PIC16C924 Rev. A Silicon Errata Sheet

The PIC16C924 (Rev. A) parts you have received conform functionally to the Device Data Sheet (DS30444D), except for the anomalies described below.

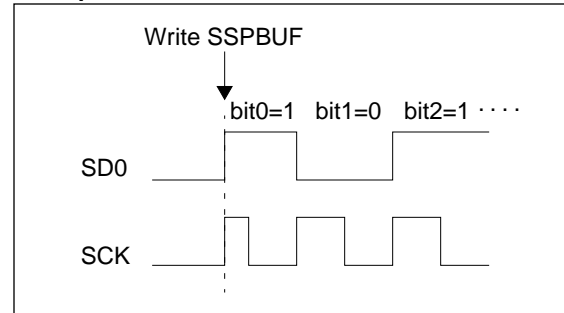
The Synchronous Serial Port module in SPI Master mode only allows the transmission of 1 byte of data at a time. The module must be disabled and then re-enabled between each byte transmission.

When the SSP is disabled, the PORTC data latch value is placed on the pins. The value in bit 3 of PORTC (SCK) should have the same value as the

idle state of SCK. For example, if the clock idles high, then bit 3 of PORTC must be set high. If bit 3 of PORTC is not configured the same as the idle state of the clock, you may experience an additional clock when the SPI is disabled then re-enabled.

Once the SSP module has been configured in SPI Master mode and one byte of data has been transmitted, wait for the interrupt flag bit SSPIF (PIR1<3>) or BF(SSPSTAT<0>) to be set. This indicates that the byte of data has been transmitted. Then, disable the SSP by clearing the SSPEN bit of the SSPCON register. Re-enable the SSP by setting the SSPEN bit. The SPI module will now transmit the next data byte written to SSPBUF.

FIGURE 1: WRITES TO TIMER1 (EXTERNAL CLOCK / OSCILLATOR MODE)

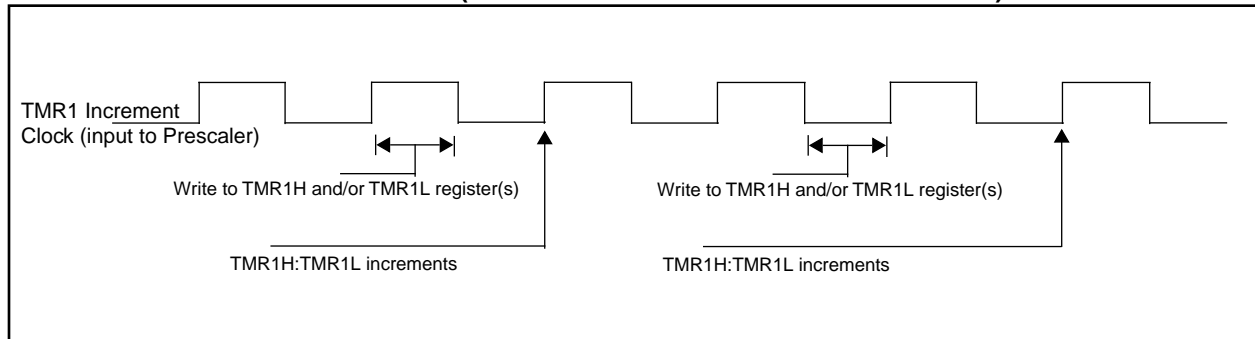
- a) The operation of Timer1 needs some clarification when the timer registers are written when the TMR1ON bit is set.

The internal clock signal that is the input to the TMR1 prescaler affects the incrementing of Timer1 (TMR1H:TMR1L registers and the Timer1 prescaler). When the Timer1 registers are NOT written, the Timer1 will increment on the rising edge of the TMR1 increment clock.

When the TMR1H and/or TMR1L registers are written while this clock is high, TMR1 will increment on the next rising edge of this clock.

When the TMR1H and/or TMR1L registers are written while this clock is low, TMR1 will not increment on the next rising edge of this clock, but must first have a falling clock and the rising clock for TMR1 to increment.

Figure 1 shows the two cases of writes to the TMR1H and/or TMR1L registers. Due to the V_{IH} and V_{IL} thresholds on the oscillator/clock pins, external Timer1 oscillator components, and external clock frequency, the Timer1 increment clock may not be of a 50% duty cycle.

The TMR1 increment clock is out of phase of the T1OSO/T1CKI pin by a small propagation delay.
